ST. JOSEPH MERCY ANN ARBOR

SRN M3431 Permit to Install 318-74C

AQD Inspection Conducted March 3, 2022

VIOLATION NOTICE

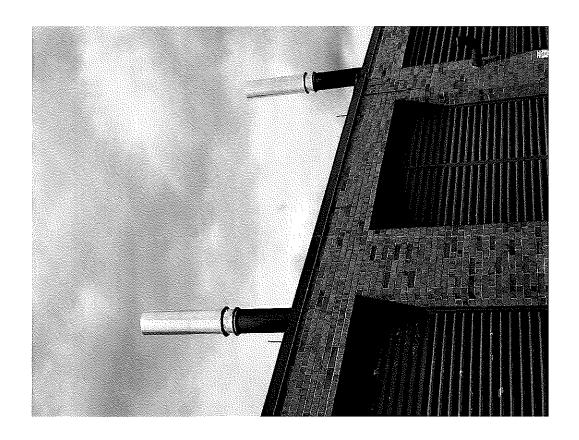
The inspection was conducted by Mike Kovalchick on March 3, 2022. The Violation Notice made note of the four generator stacks had flipper type rain caps. The response was to contract for the installation of compliant No Loss Rain Stacks on all four exhaust pipes.

Process Description	Rule/Permit Condition Violated	Comments
FGENGINES- Four diesel fuel-fired reciprocating engines driving electric generators.	PTI 318-74C Special Condition VIII. STACK/VENT RESTRICTION(S)- 1. SVENGINE1, 2. SVENGINE2, 3. SVENGINE3, 4. SVENGINE4.	4 stacks do not vent unobstructed vertically upward; have flipper style caps on top of exhaust stacks.

This communication confirms the no-loss rain stacks have been installed. Please see attached pictures.
